Addendum No. 001

**Subject:** G.W. Carver Commons  
General Construction, Electrical  
SDP Contract No. B-070C, B-071C of 2018/19

**Location:** G.W. Carver High School  
1600 W. Norris Street  
Philadelphia, Pennsylvania 19121

This Addendum, dated April 25, 2019, shall modify and become part of the Contract Documents for the work of this project. Any items not mentioned herein, or affected by, shall be performed strictly in accordance with the original documents.

DRAWING NO.  
E-301

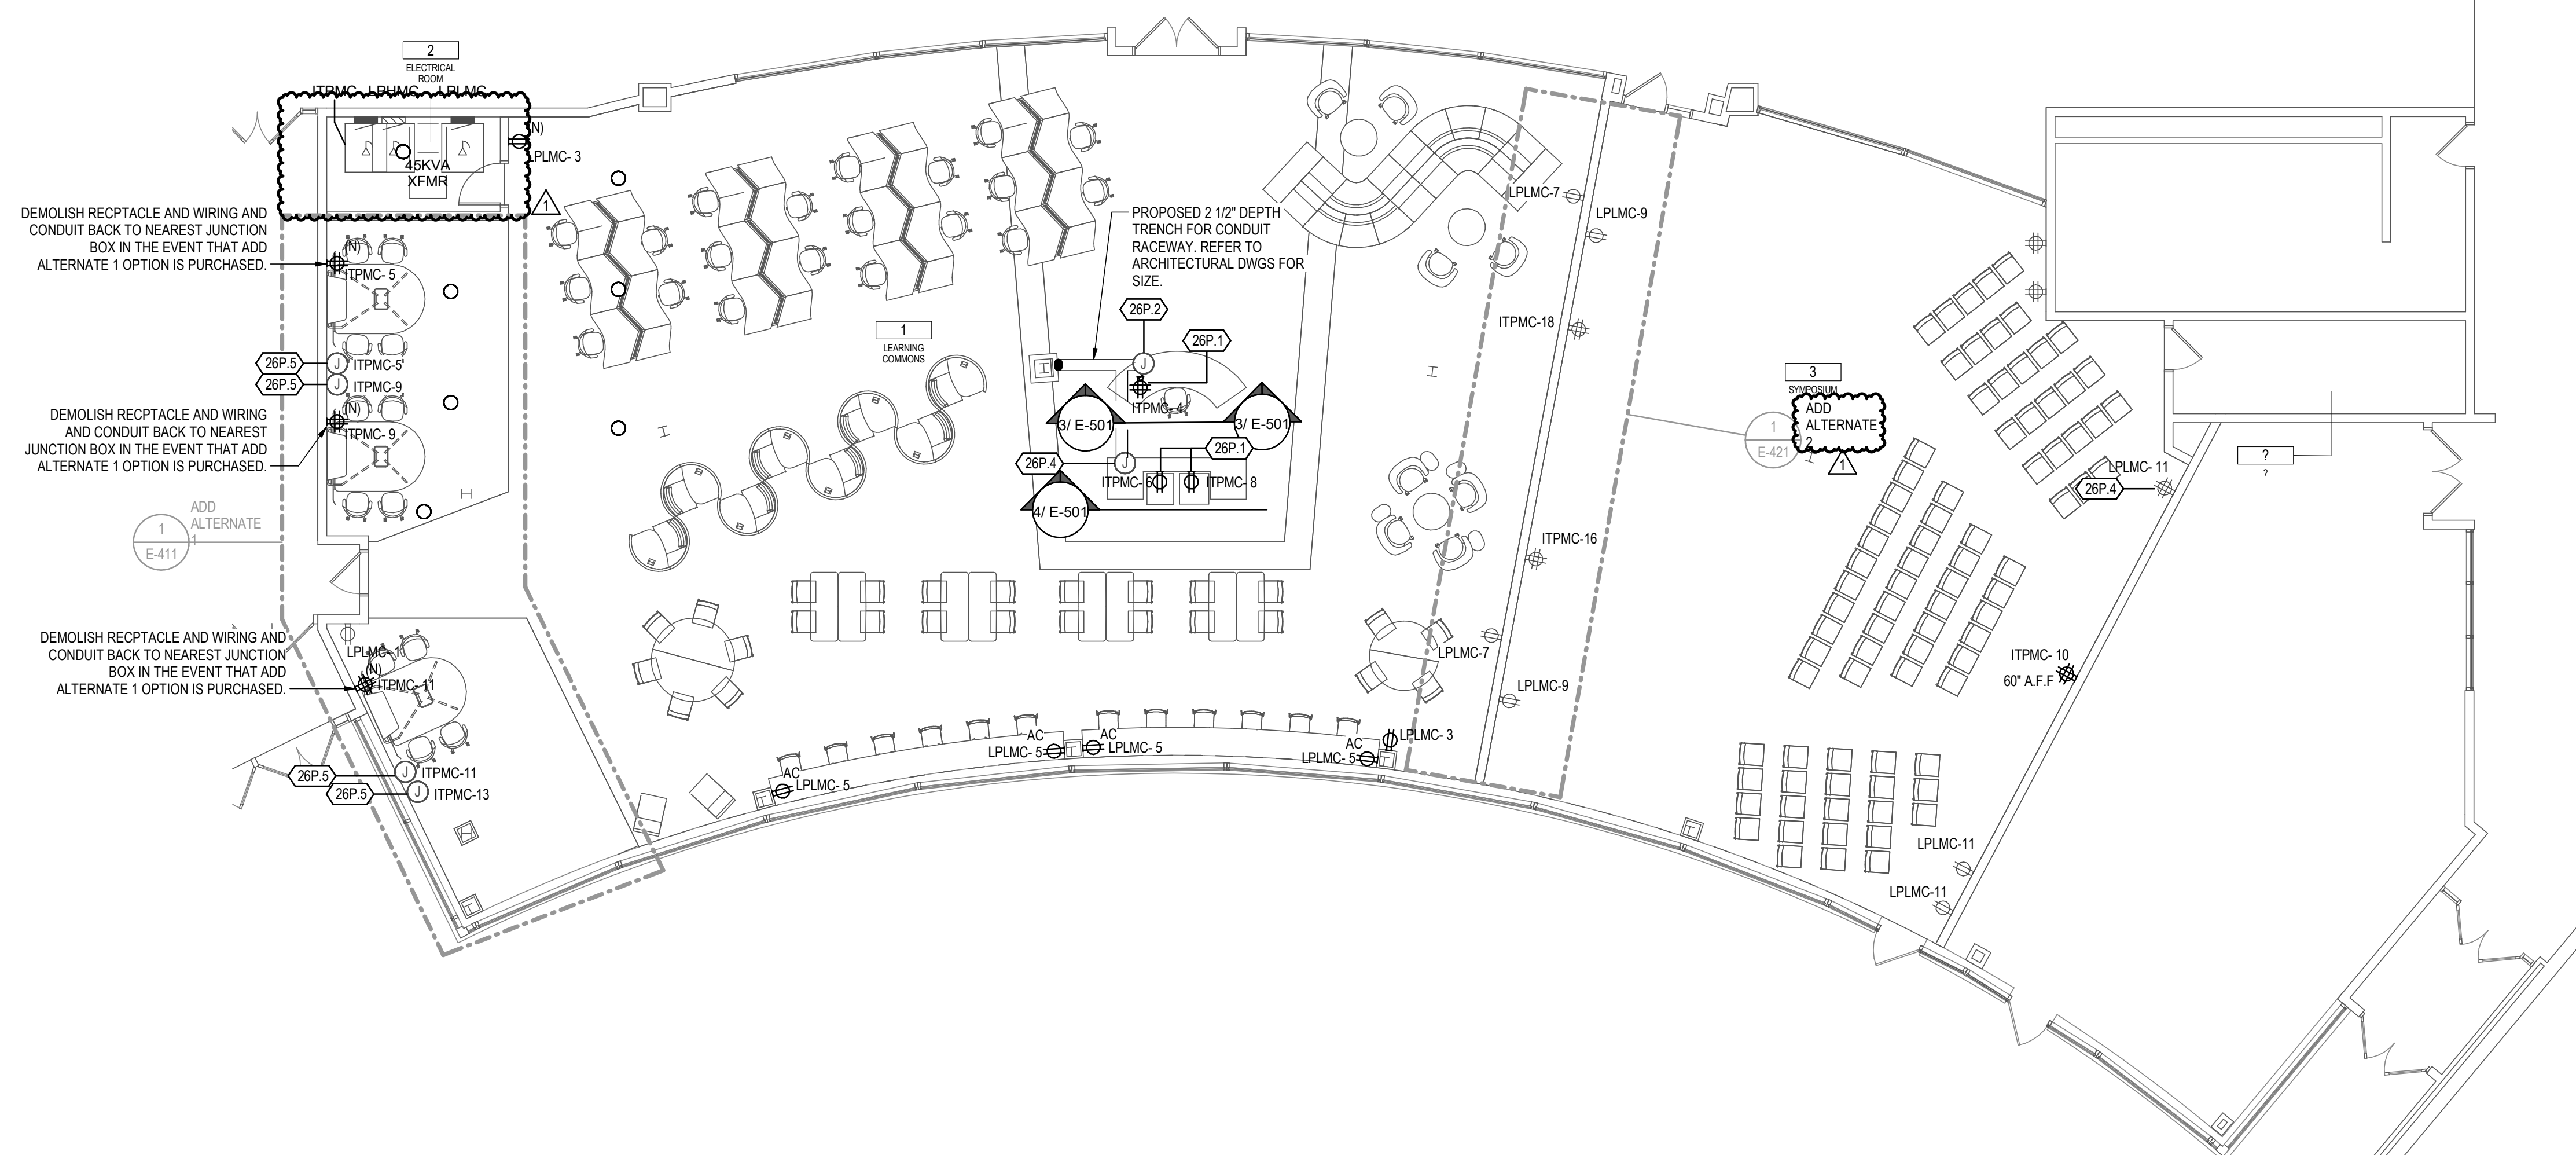
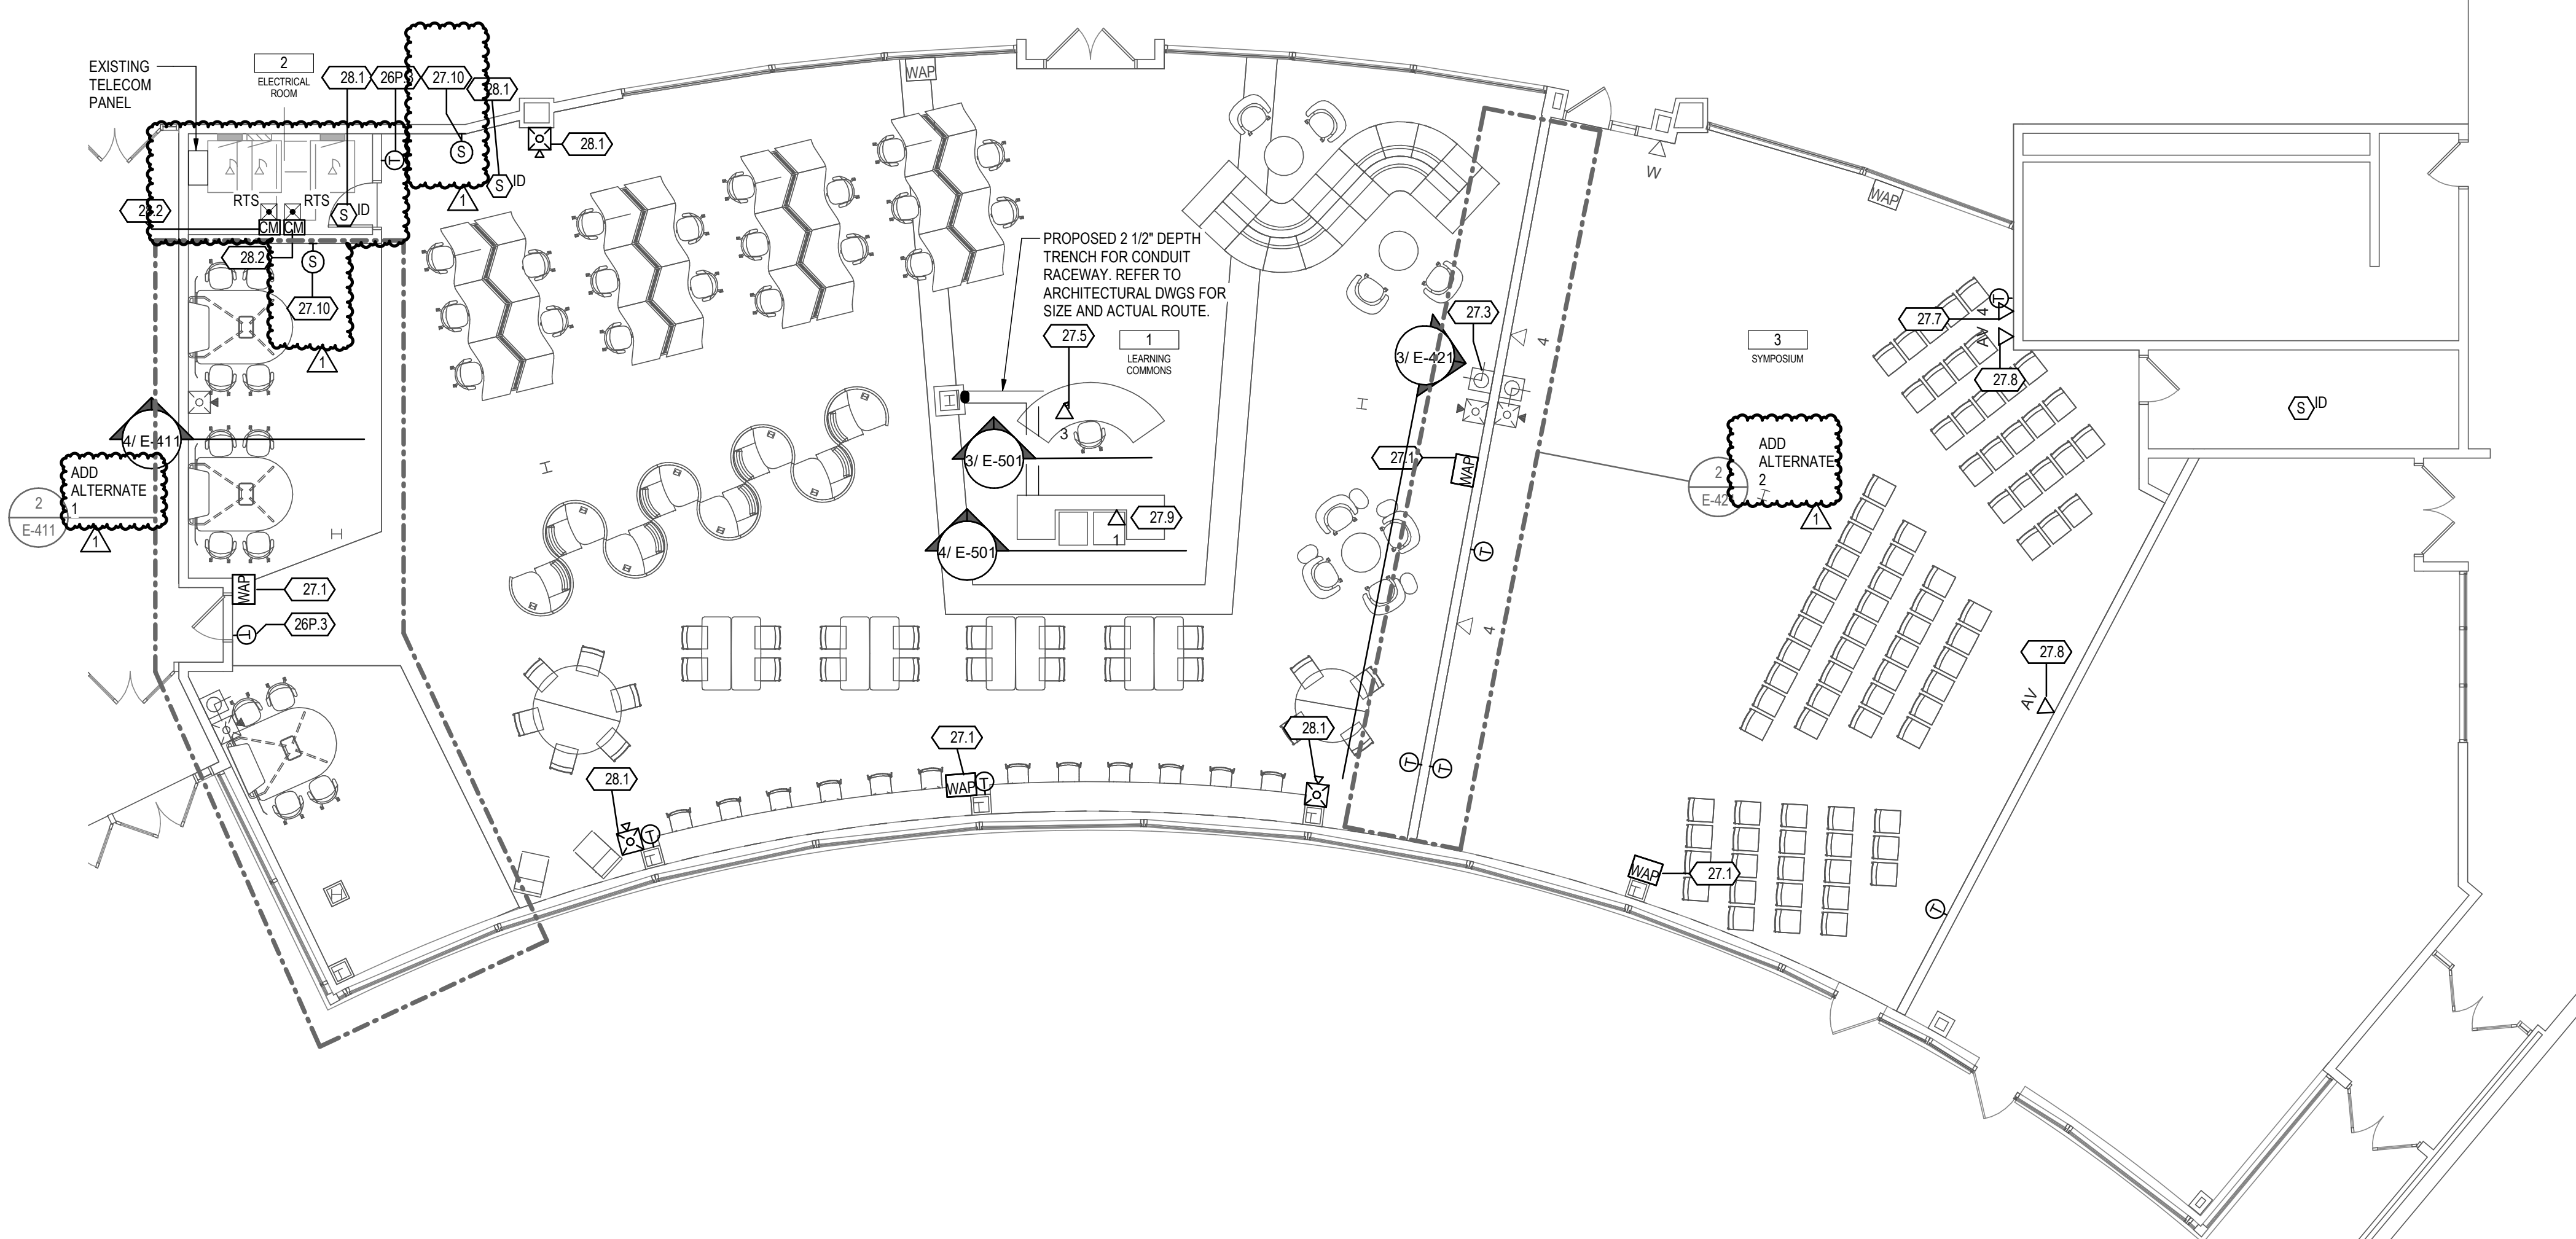
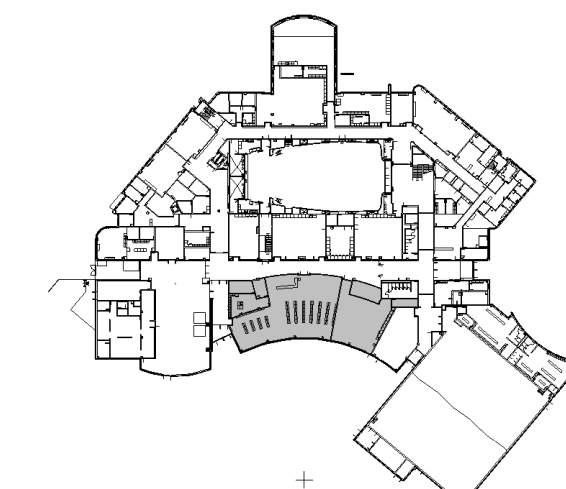
- **E-301 FIRST FLOOR POWER & SYSTEMS NEW WORK FLOOR PLANS:**
  - Included electrical scope of work for relocations of existing PA speakers in the new work scope of work.

- Added keynote 27.10 regarding PA speakers scope of work.
  - Edited callout box section to graphically indicate Add Alternate 1 scope of work area more precisely.

- Edited callout box section to graphically indicate Add Alternate 2 scope of work area more precisely.
- **E-411 FIRST FLOOR ELECTRICAL ADD ALTERNATE 1 PLANS:**

E-411

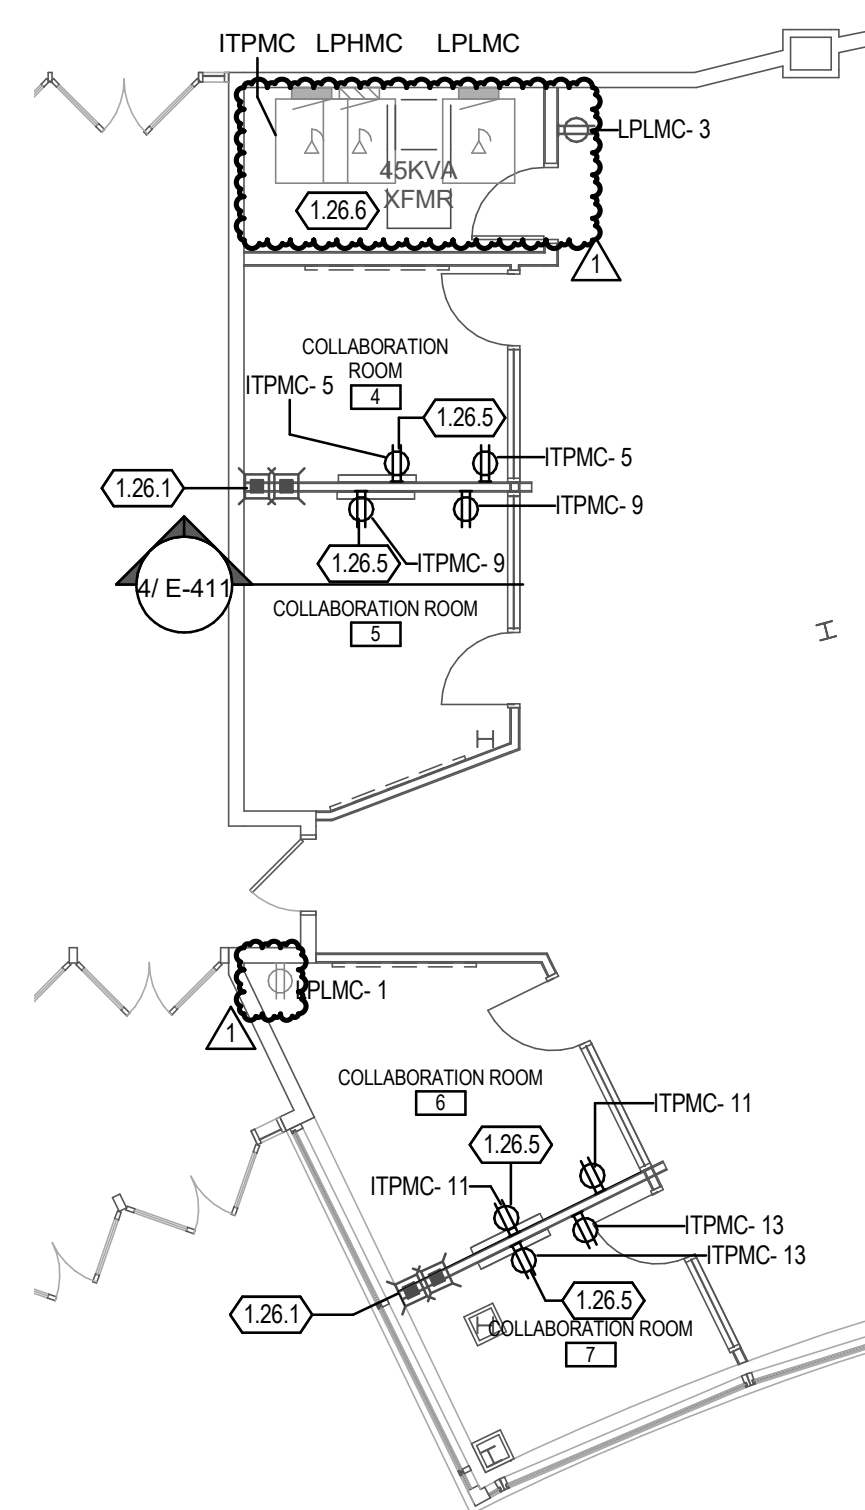
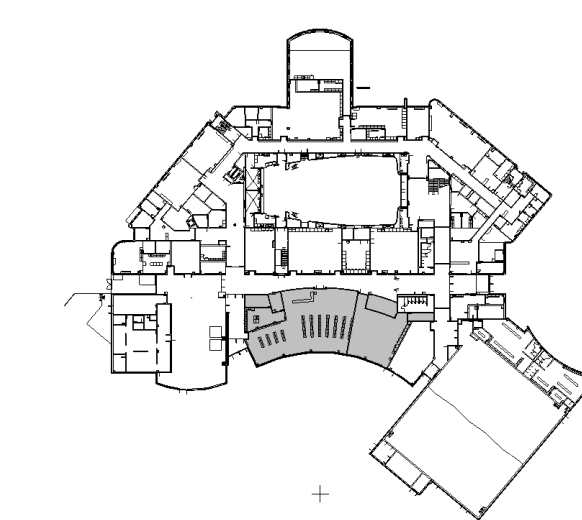
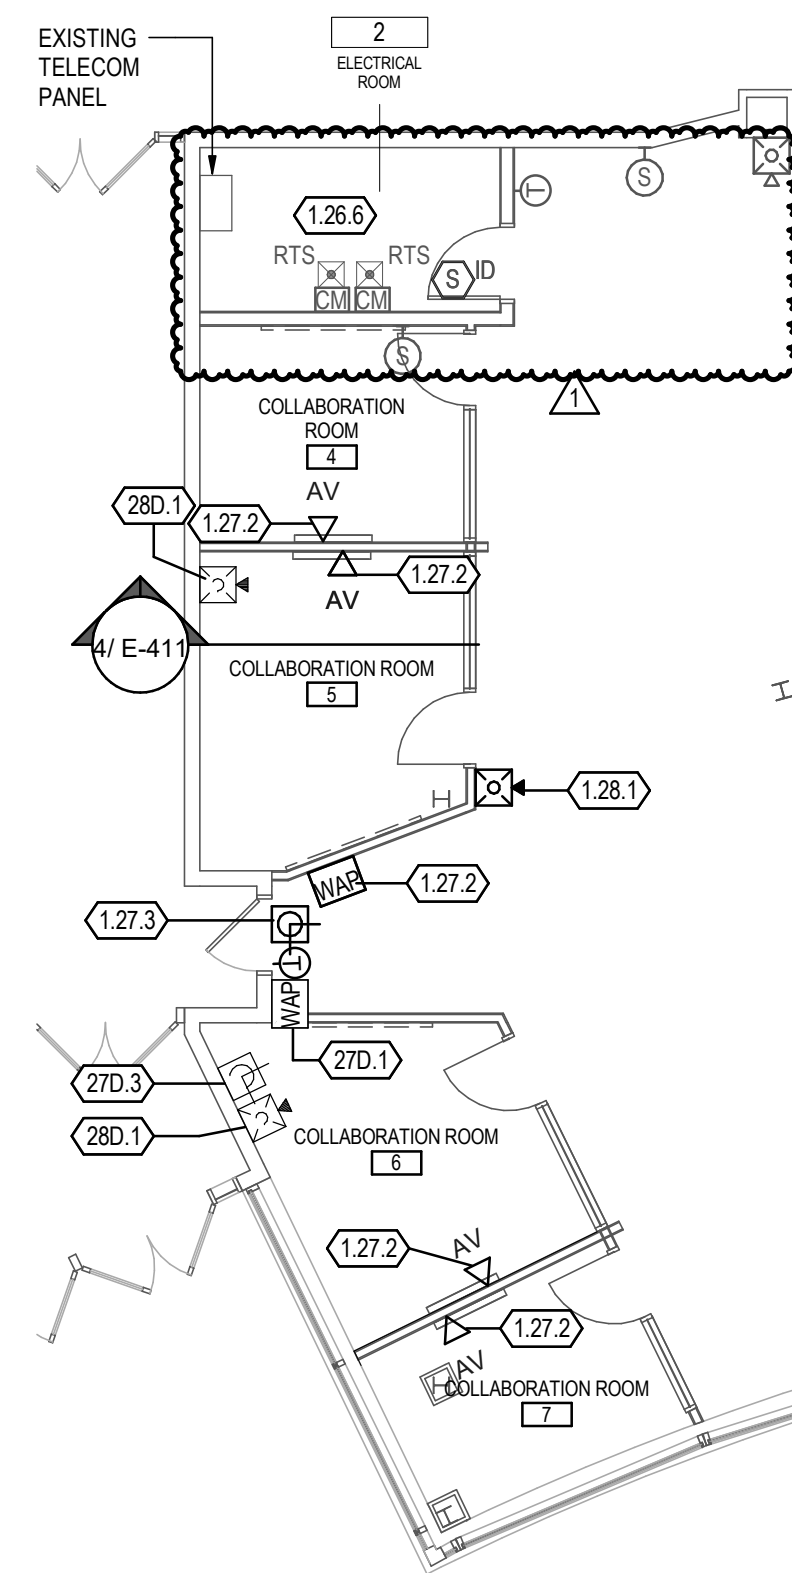
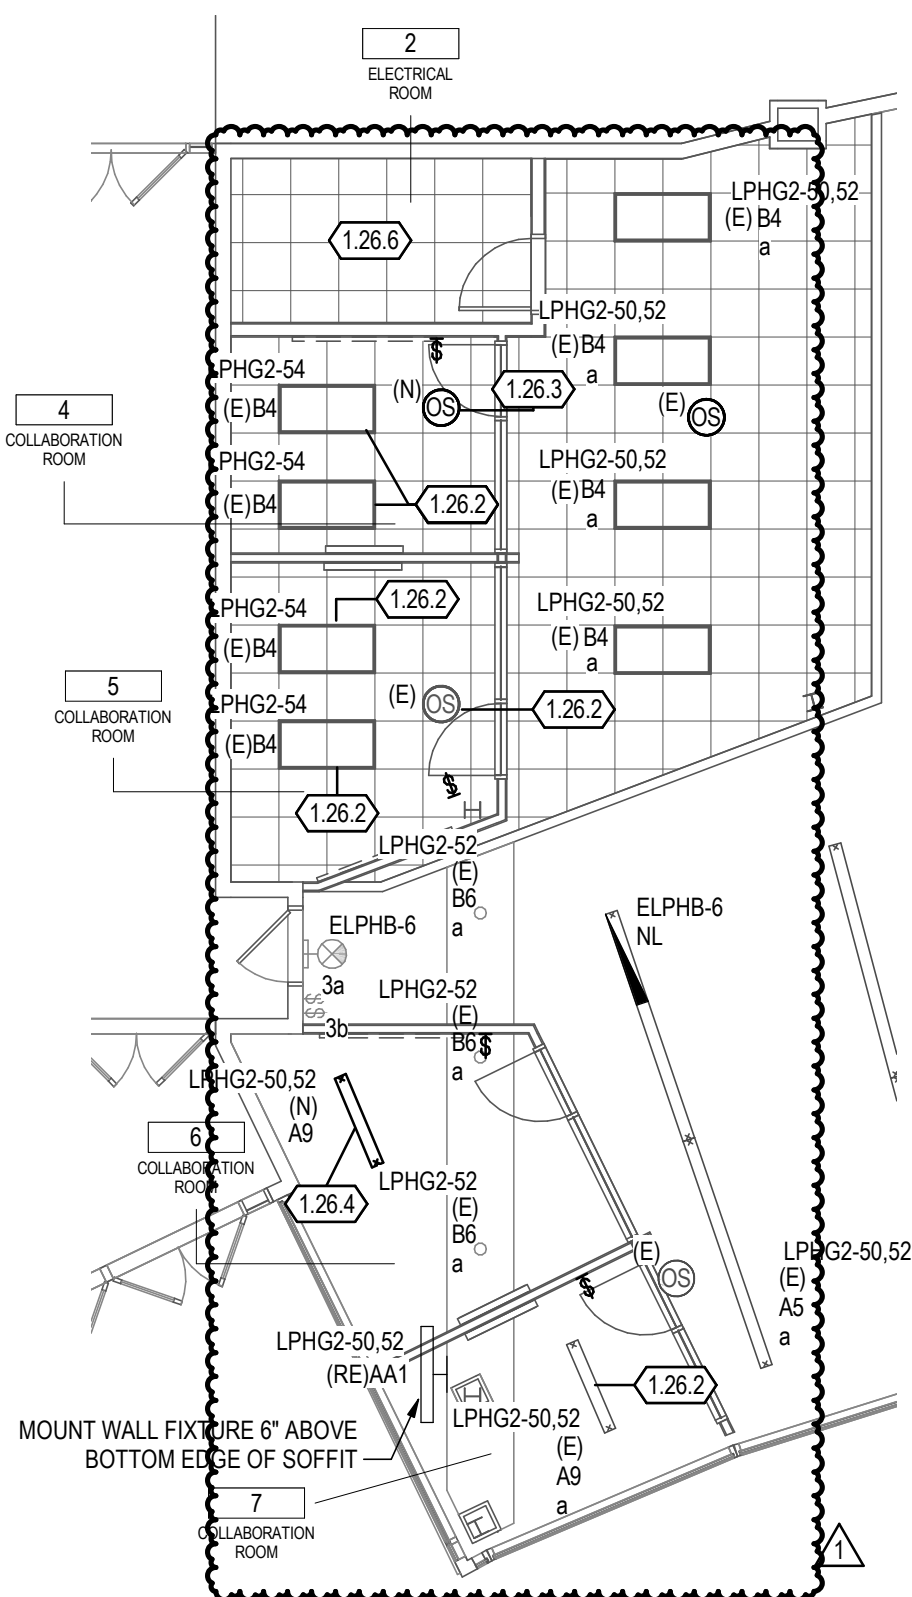
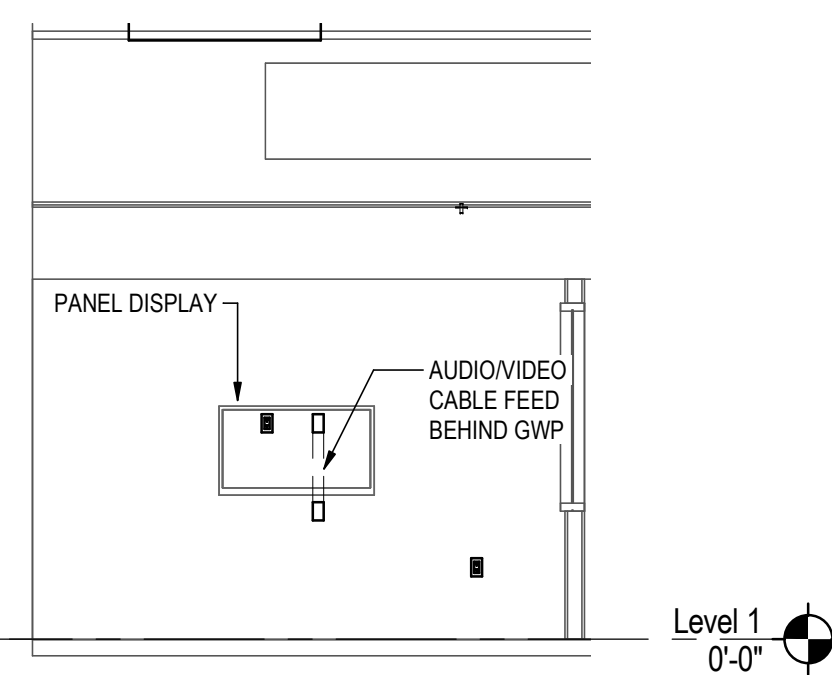
- Added "New Construction Notes – Add Alternates" General note to sheet.
  - Graphically edited devices and fixtures that are only part of base bid to be halftone for all plan views.

- Added keynote 1.26.6 to indicate base bid scope of work reference.
- **E-412 FIRST FLOOR ELECTRICAL ADD ALTERNATE 2 PLANS:**
  - Added "New Construction Notes – Add Alternates" General note to sheet.
